BOARD OF HEALTH

NOTIFICATION TO OWNER

Property Address: **602 SUMMER STREET, MANCHESTER-BY-THE-SEA**

Title 5 Official Inspection Form

JOB 602 SUMMER ST

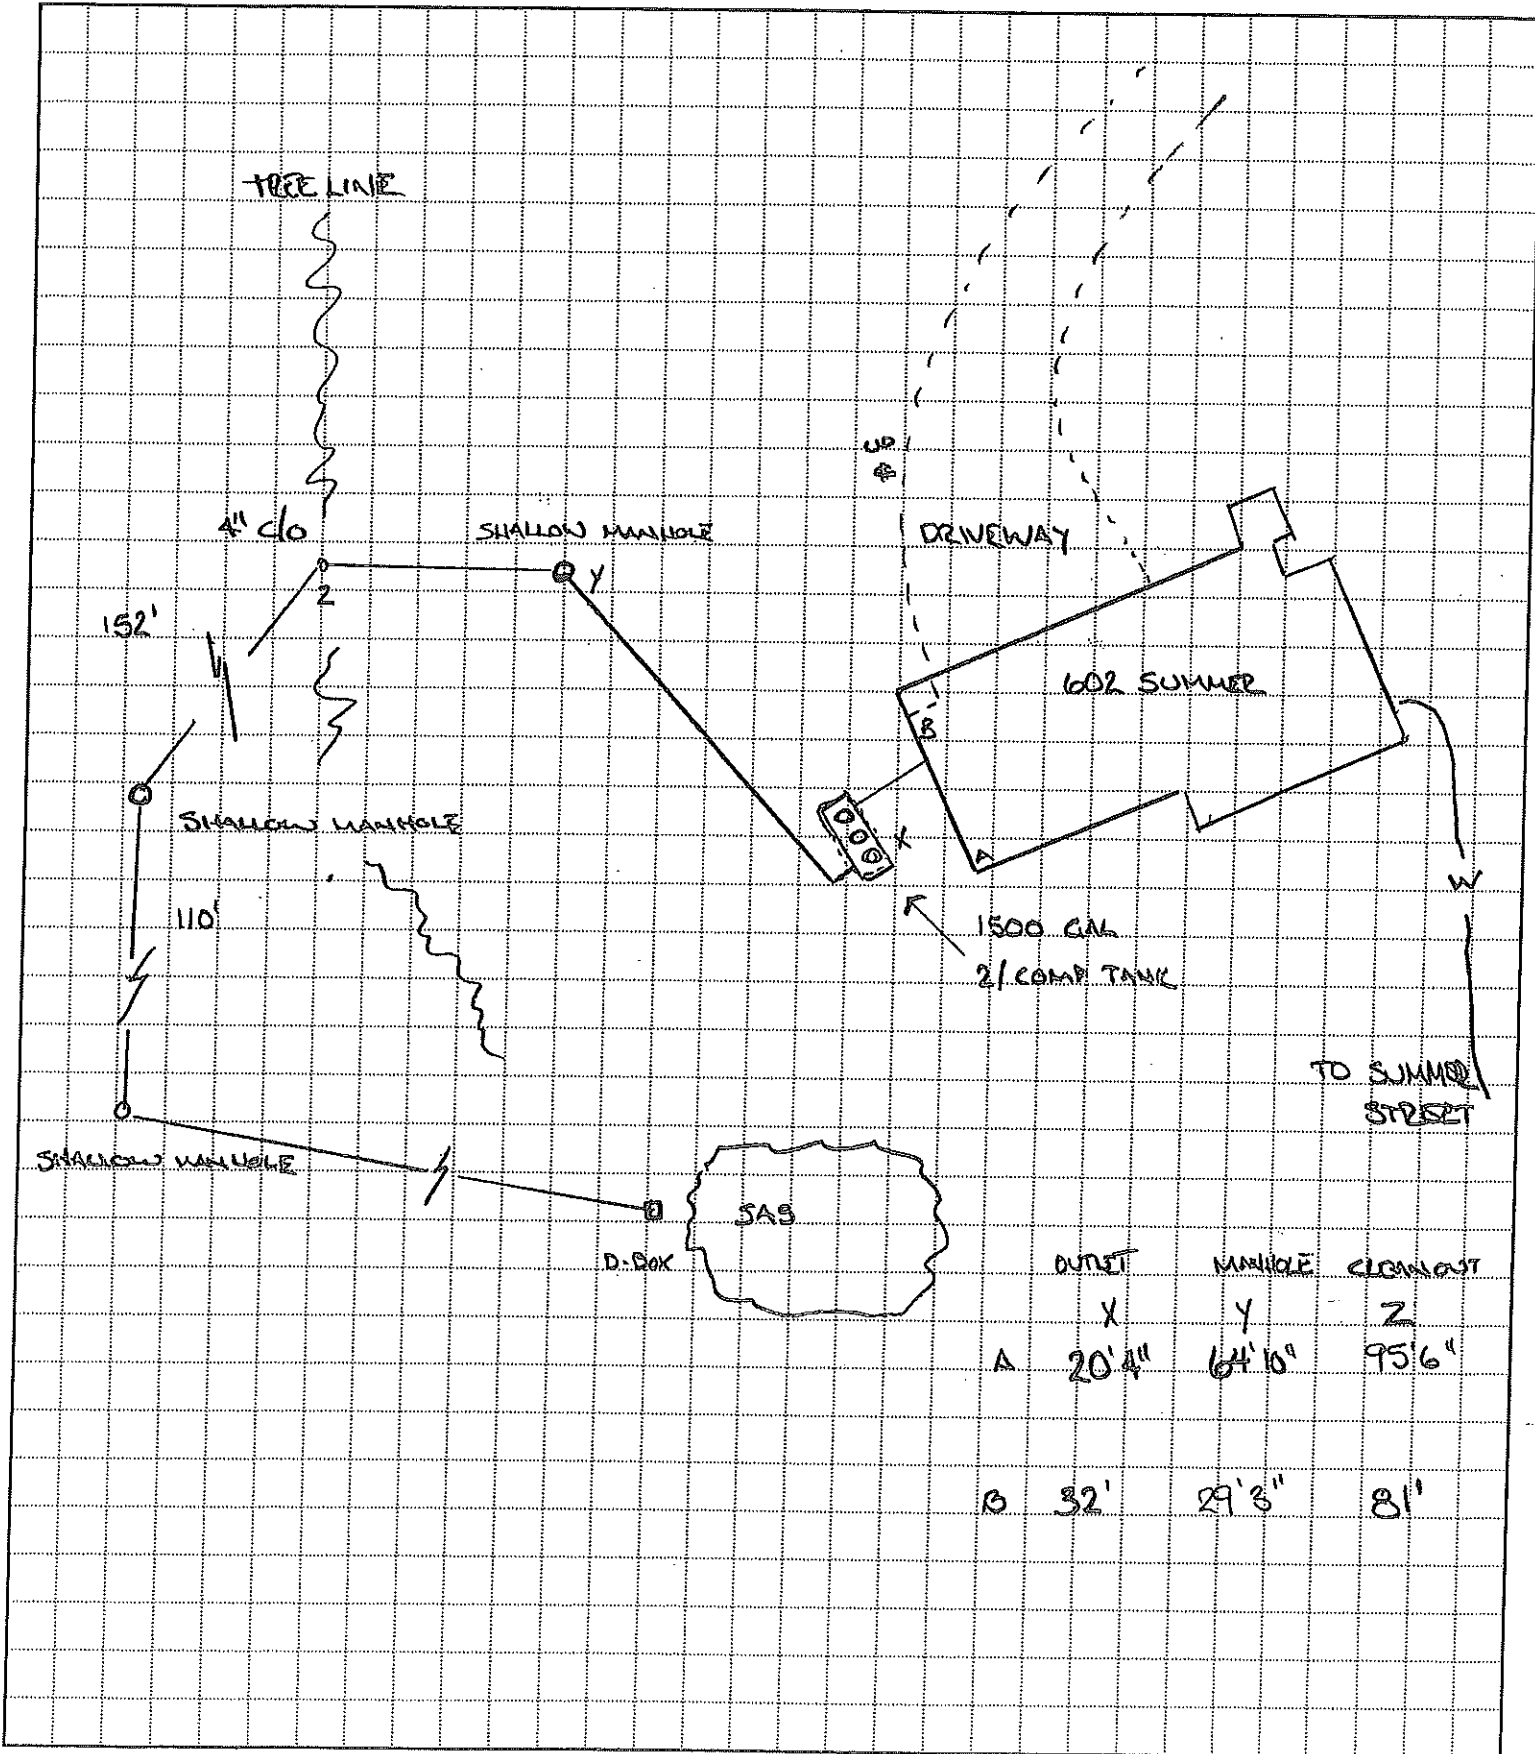
NOTE: The septic tank was not pumped as part of the inspection.
The grinder pump at the pool house connected by a force main to the main house building sewer are not noted.
